ADDENDUM NO. 7

Reference: Northern Utah Interagency Fire Dispatch Center
DNR – Draper, Utah
Project No.10013500

Northern Utah Interagency Fire Dispatch Center

ADDENDUM NO. # 07

SHEET NUMBER:
EL501

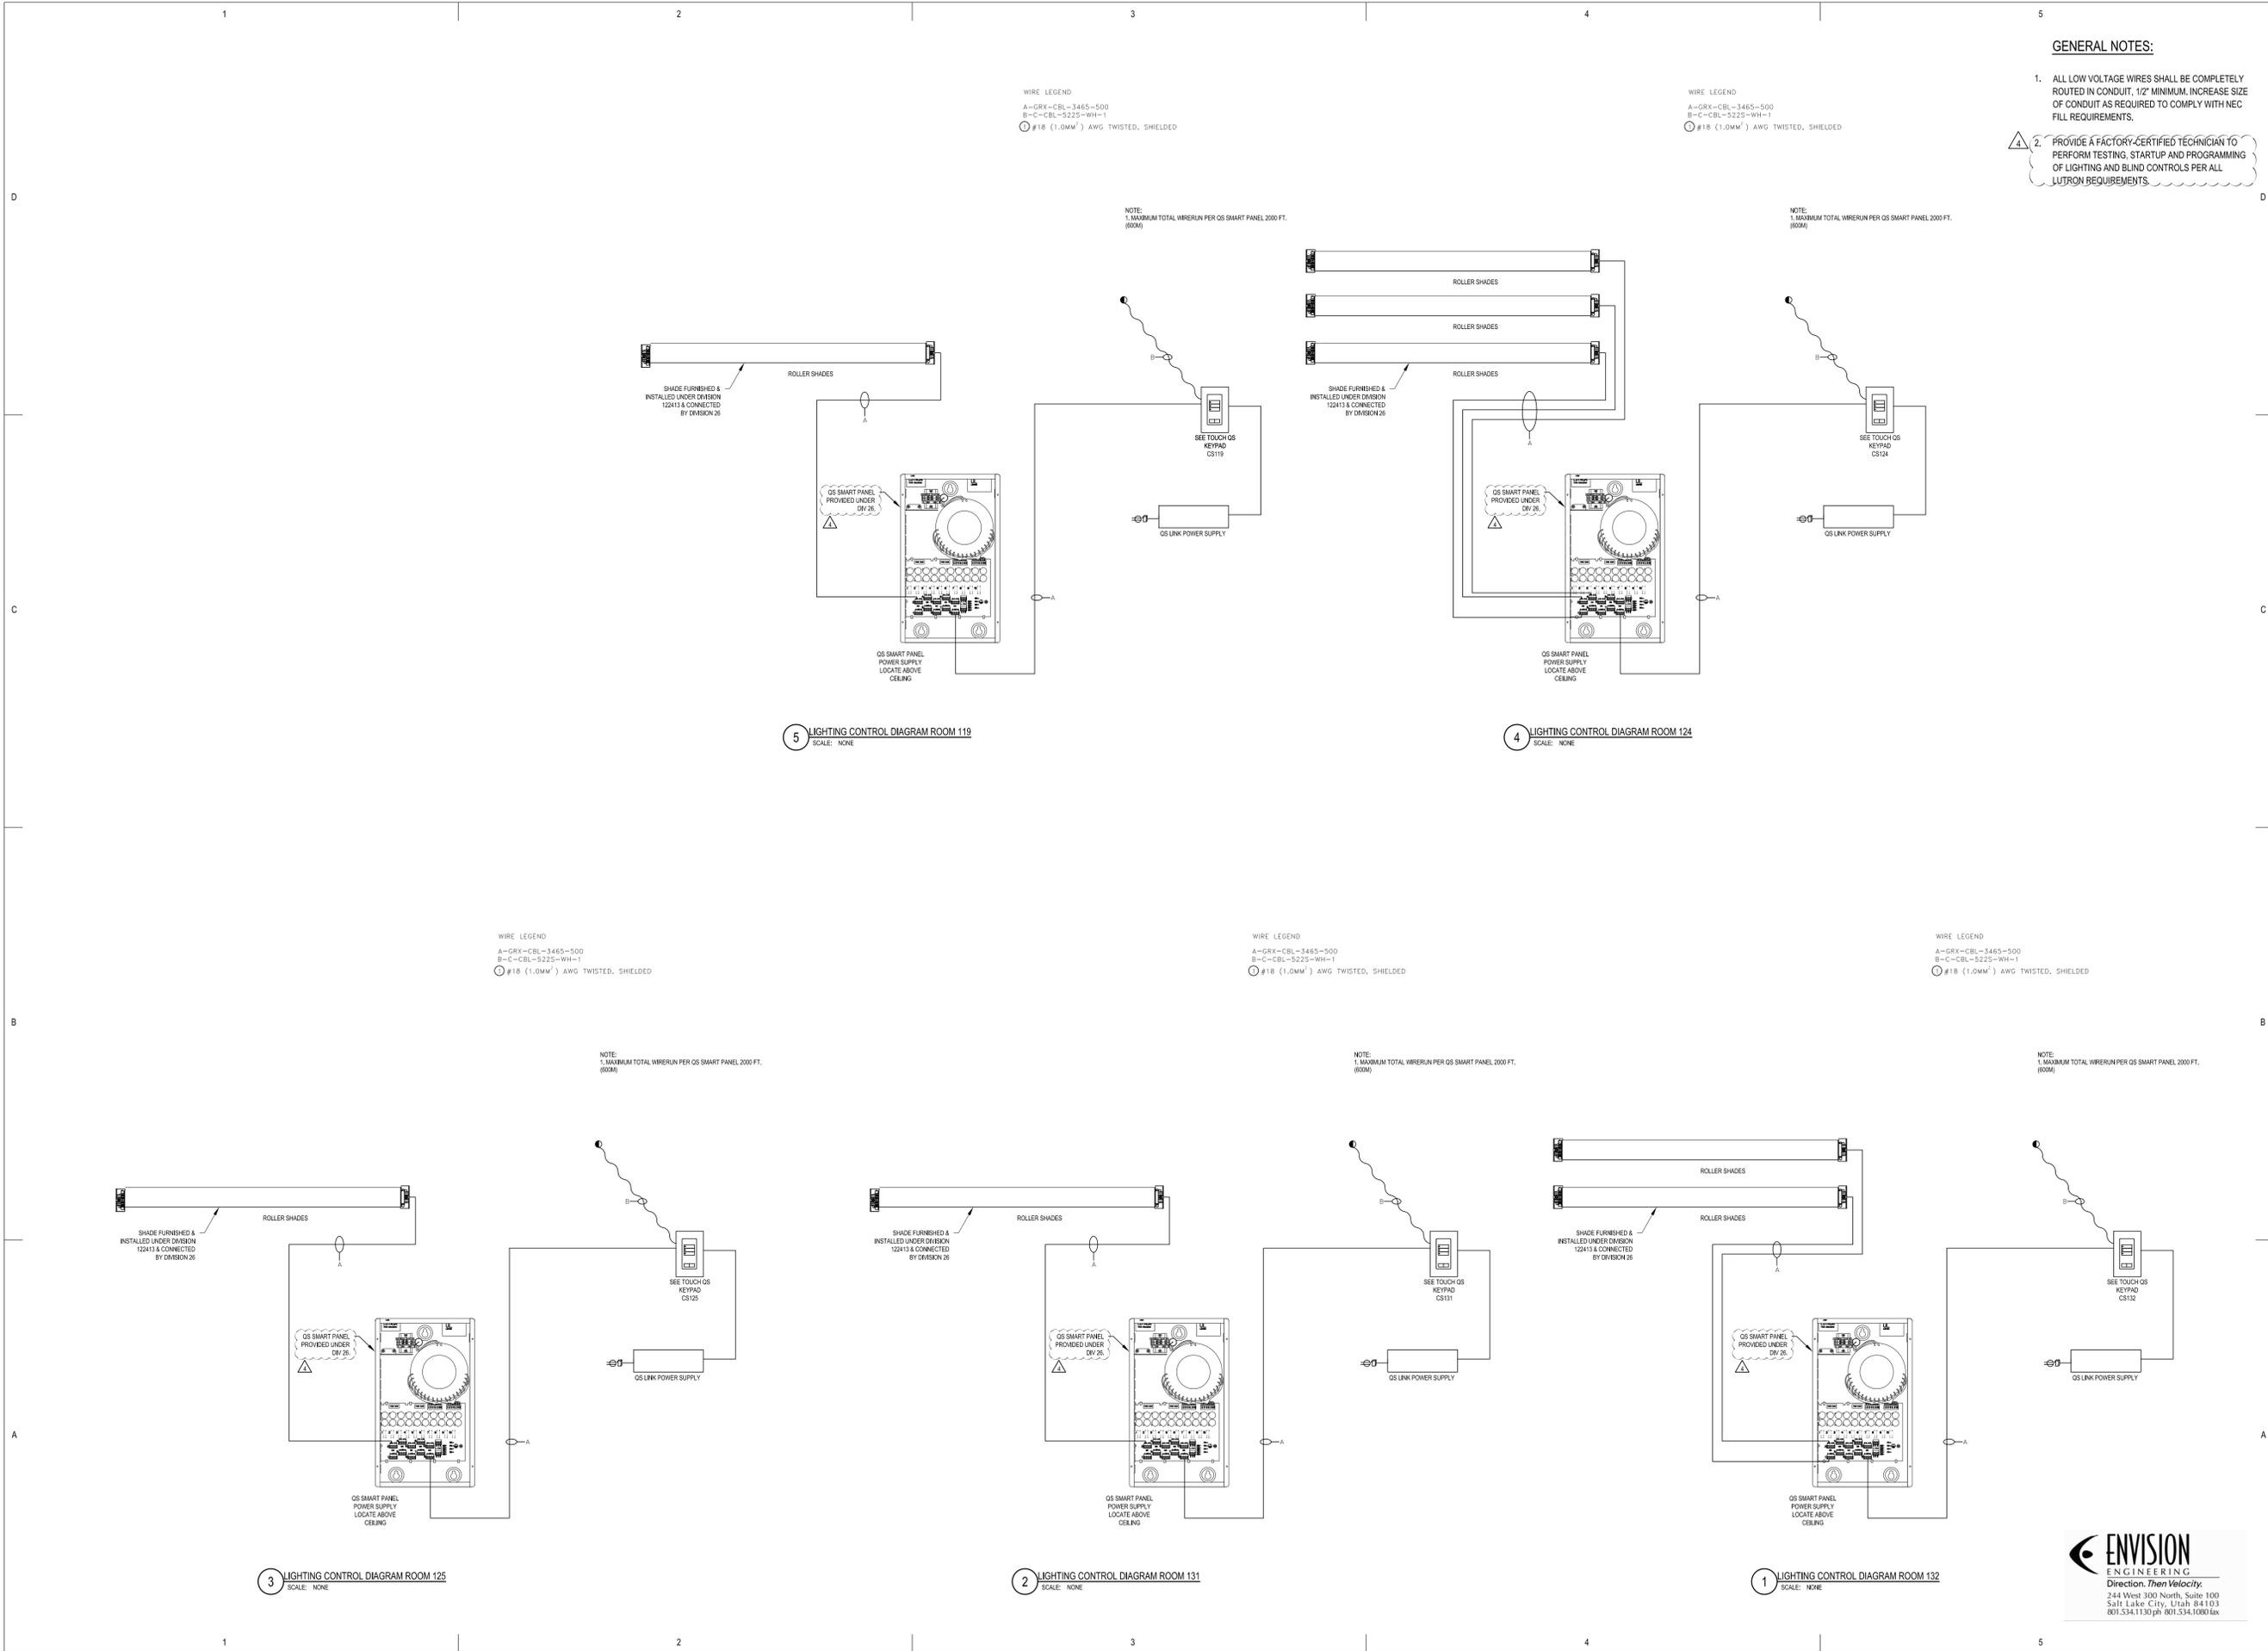
SHEET EL501 & EL502: Lighting Details

1. All QS Smart Panels to be provided under Division 26. Testing, Start-up and programming of lighting and blind controls shall be provided as part of contract by a factory-certified technician and per all Lutron requirements. Refer to EL501 and EL502 for clouded changes.
2. All changes associated with the shade control system have been made on drawings. No specification section changes necessary. Refer to EL501 and EL502 for clouded changes.
3. Add general note as follows. “For the emergency branch, provide over current protective devices in ratings and types as may be required to achieve selective coordination per all NEC requirements down to the .01 level. Please note that panel ‘E1’ shall be a Bussmann Quik-Spec fused panel; an equivalent fused panel from Littlefuse is also acceptable.”

SHEET NUMBER:
EP101

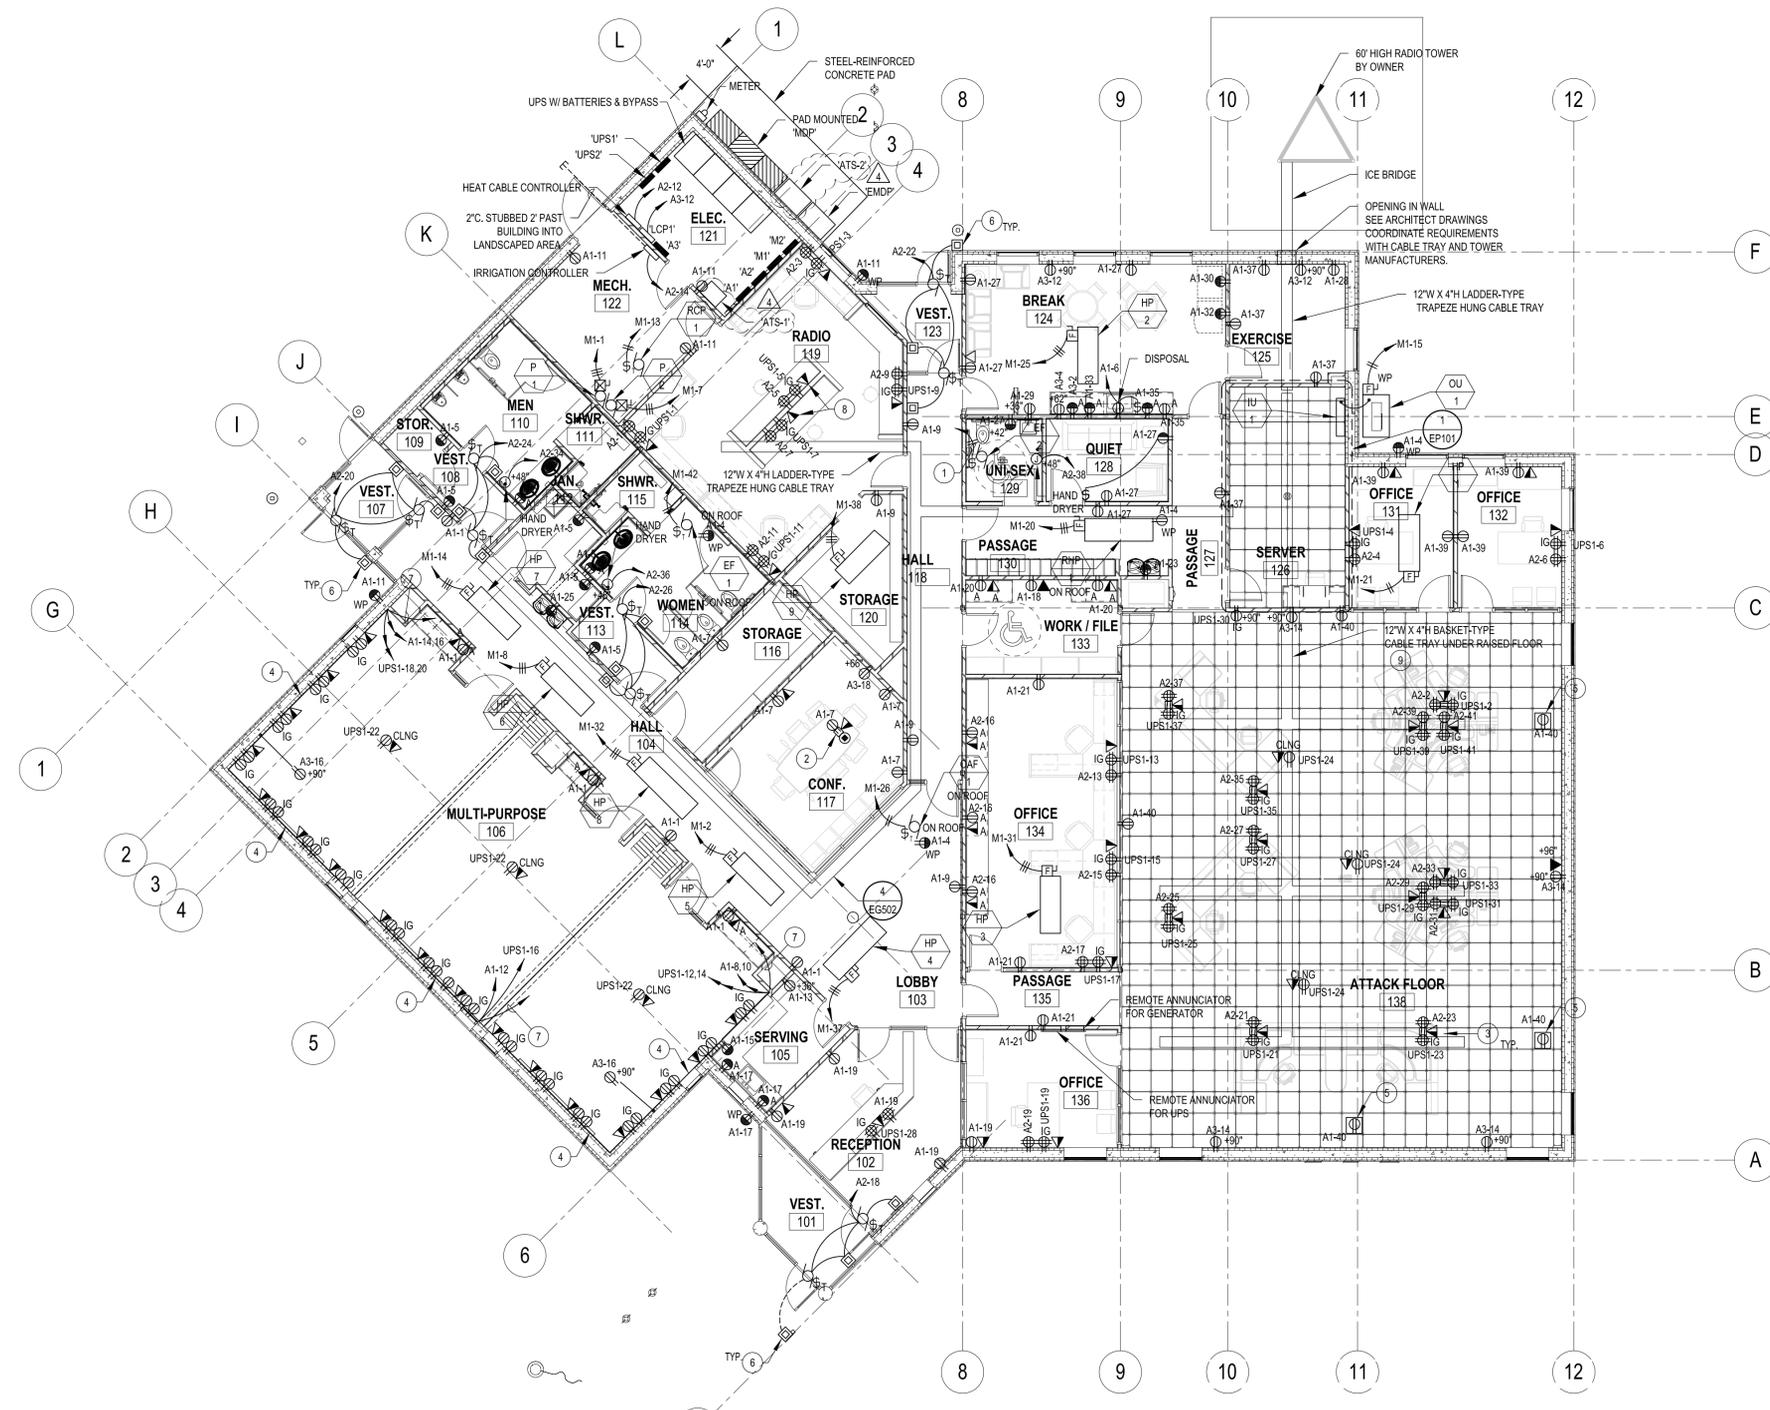
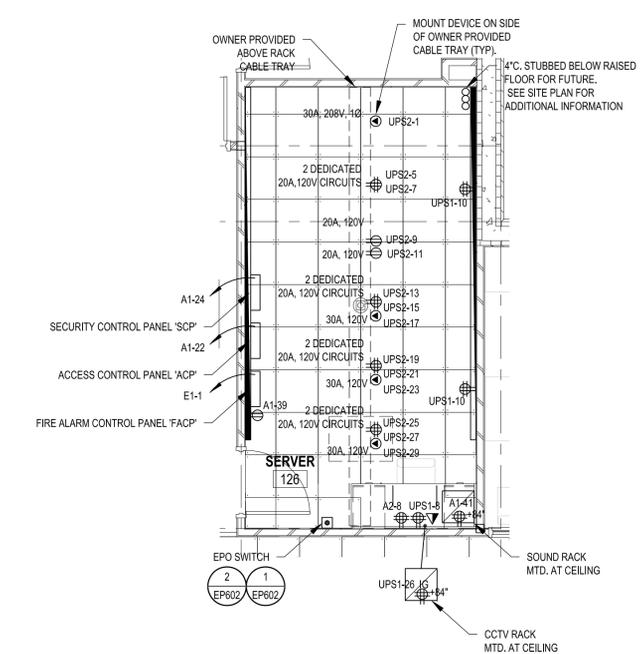
SHEET EP101: Power plan

1. Change MDP gear sizes and locations. Refer to EP101 for clouded changes.

SHEET NUMBER:
EP701

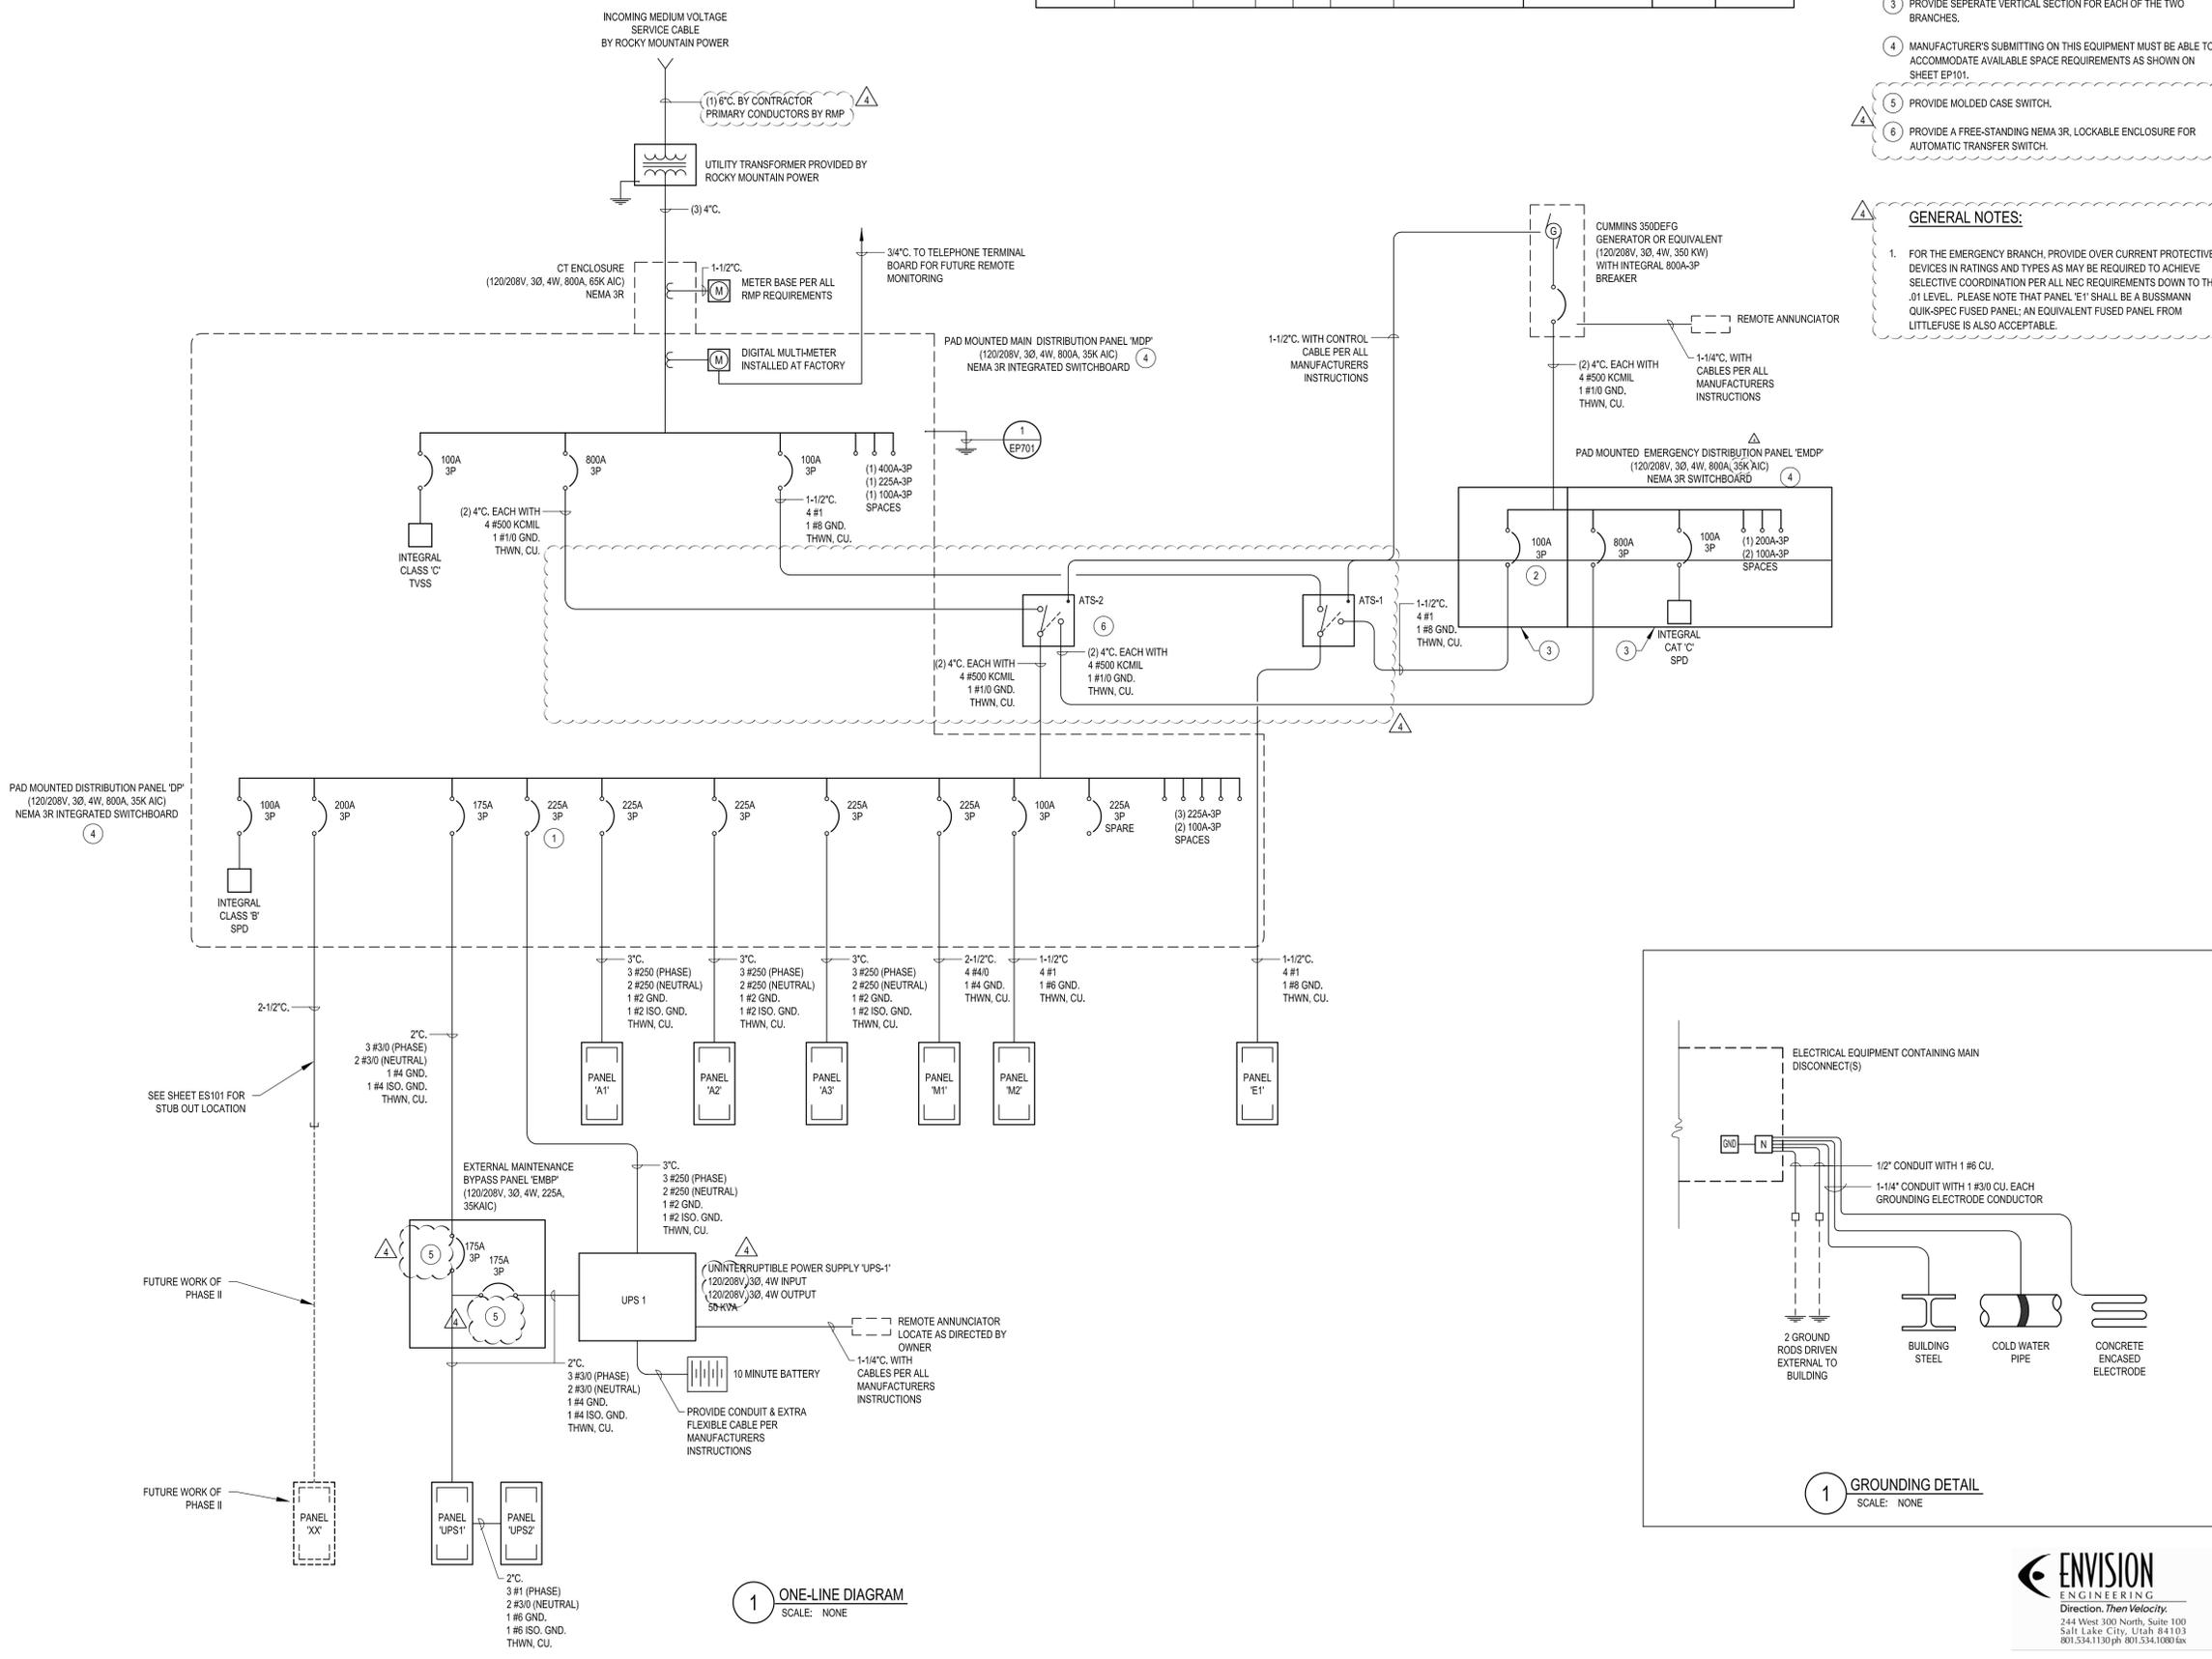
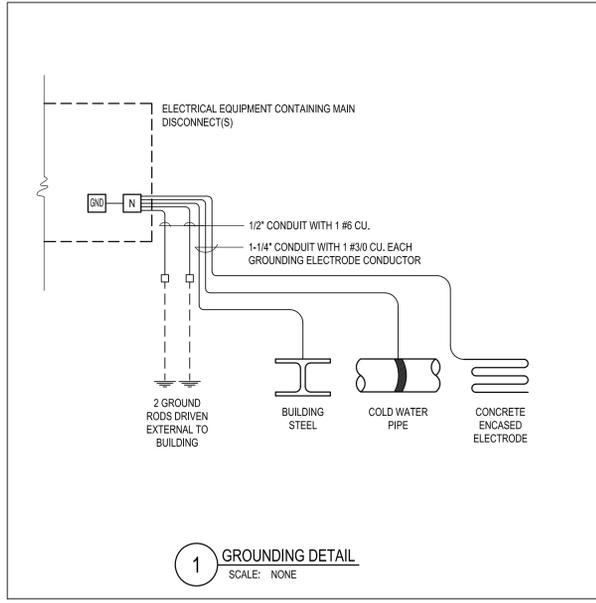
SHEET EP701: One-line diagram

1. Change breakers in external maintenance bypass to molded case switches. Refer to EP701 for clouded changes.
2. Change UPS-1 to 120/208v, 3-phase, 4-wire input and output. Refer to EP701 for clouded changes.
3. Change configuration of main distribution panel ‘MDP’. Refer to EP701 for clouded changes.
4. Change conduit size into RMP transformer to 6”. Refer to EP701 for clouded changes.
5. Change EMDP AIC rating. Refer to EP701 for clouded changes.
6. Remote annunciator and generator are included in project, shown dashed to indicate a separate enclosure or cabinet.
